Wulfsberg Electronics <i>A Chelton Group Company</i>			
APPROVALS		DATE		TITLE: SERVICE BULLETIN WSB IDU-III-9 (DEPARTURE AND MISSED APPROACH PROCEDURE)	
DRAWN Robert DuRall		11/18/2003			
CHECKED Dean Boston		11/18/2003			
PRODUCT MANAGER Mark McCormack		11/18/2003			
ENGINEER		SIZE	CAGE CODE	DWG NO.	REV
ISSUED Vern Wallace		A	1B7G3	150-045973	A
Typed signatures indicate approval. Handwritten signature approval of this document is on file at Wulfsberg Electronics, Prescott, Arizona.		SCALE: NONE		DO NOT SCALE DRAWING

SERVICE BULLETIN

BULLETIN NUMBER: WSB IDU-III-9 Revision A

REASON

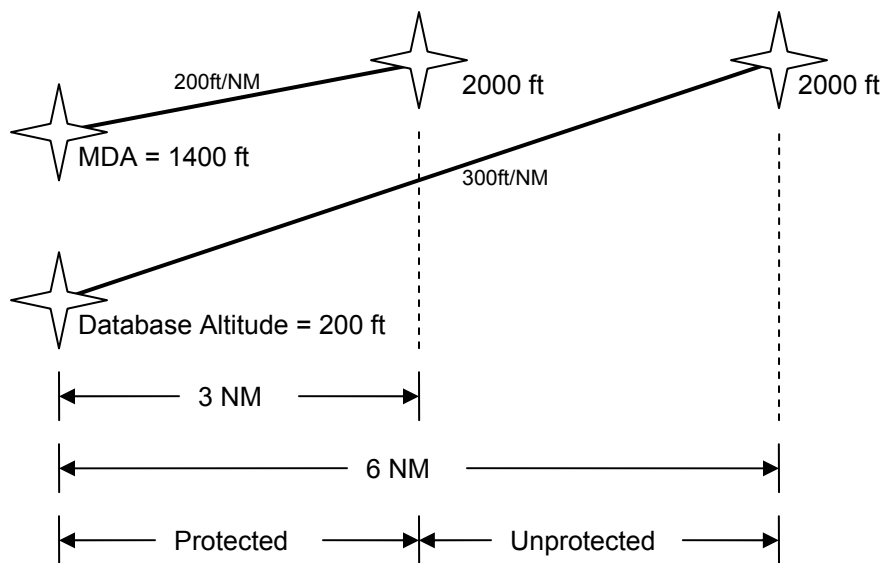
In the current software, altitude leg length is pre-computed based upon database start and end altitudes and a climb rate of 300 feet per nautical mile. The software then places a phantom fix (waypoint symbol without a name) at the calculated end of climb point that is used for navigation guidance. This methodology does not take into account the aircraft's actual climb performance. The diagram below shows how altitude leg length is computed in the current software:

$$\text{Leg Length} = (2000\text{ft} - 200\text{ft}) / 300\text{ft per NM} = 6\text{NM}$$

This methodology is safe under most circumstances because 300 feet per nautical mile exceeds the standard TERPS climb rate of 200 feet per nautical mile. However, under certain circumstances, this methodology can result in hazardously misleading guidance into non-protected areas. These circumstances are described below:

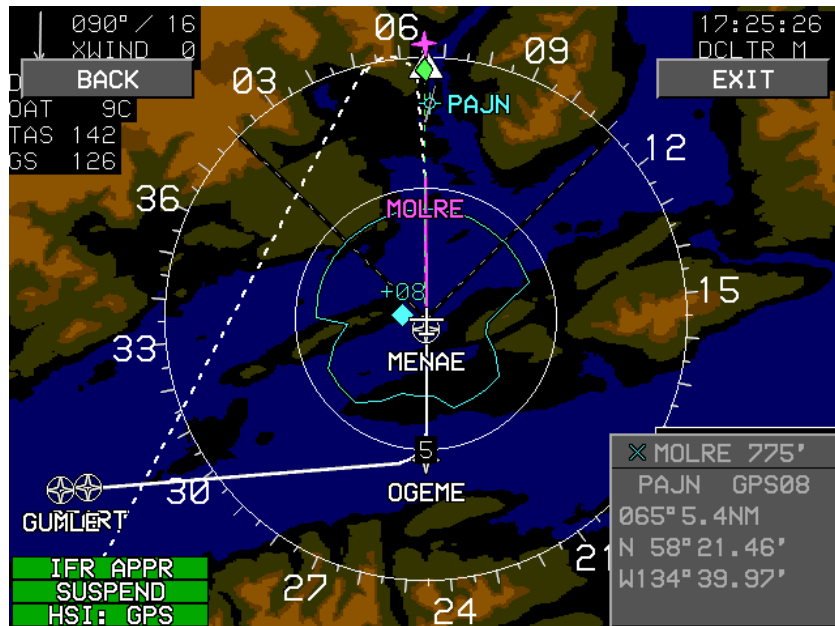
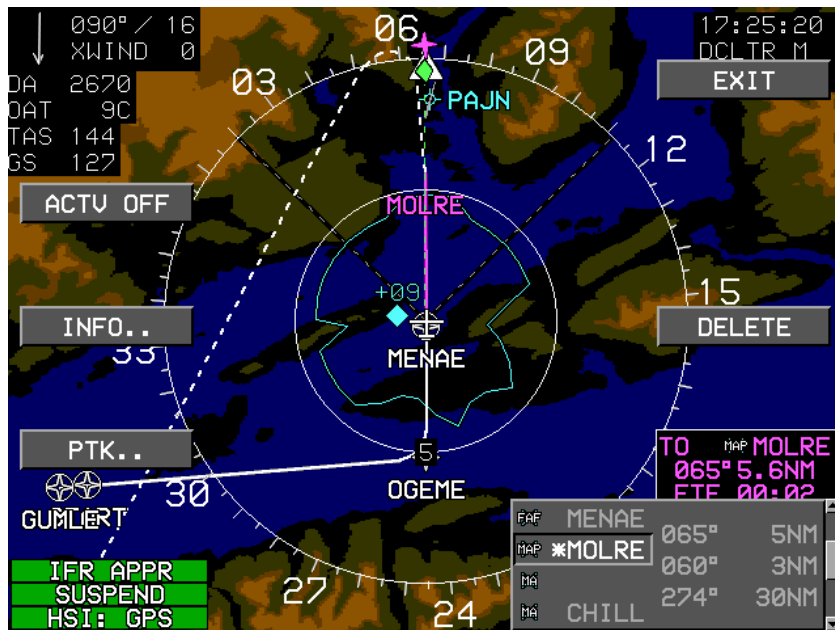
Under ARINC424 rules, whenever there are straight-in minimums for an instrument approach procedure, the database Missed Approach Point (“MAP”) altitude will be coded so as to provide a stabilized approach to the designated straight-in runway and will not reflect the MDA or DH for the approach. In the case where the database MAP altitude is lower than the MDA or DH, and the first leg of the missed approach procedure is an altitude leg, the altitude leg length calculated by the current methodology may exceed the designed protected length. This is depicted graphically below:

1. Review the approach plate for the procedure. If the first leg of the missed approach is an altitude leg, then there is the possibility of hazardously misleading guidance into non-protected areas.
2. Review the active flight plan waypoints using the <ACTV> button. Highlight the MAP (identified by the letters “MAP” over the waypoint symbol in the active flight plan list). Use the <INFO> option to view the database MAP altitude. In the screen captures below, the database MAP altitude (waypoint MOLRE) is displayed as 775’:

3. If the database altitude is below the MDA or DH published for the approach then, workload permitting, the following formula can be used to determine whether there is hazardously misleading guidance into non-protected areas:

$$\text{Climb from database altitude} > 1.5 \times \text{Climb from MDA/DH}$$

4. If the guidance is hazardously misleading, the operator must ignore the guidance and fly the missed approach procedure manually by reference to the published approach plate only. It is recommended that Highway in the Sky guidance be decluttered from the PFD in this condition. The operator should also keep in mind that the terrain display function is unaffected by this condition and continues to provide situational awareness cues.
5. In all cases, the published approach plate takes precedence over the database derived approach guidance. ALWAYS comply with the published approach plate.
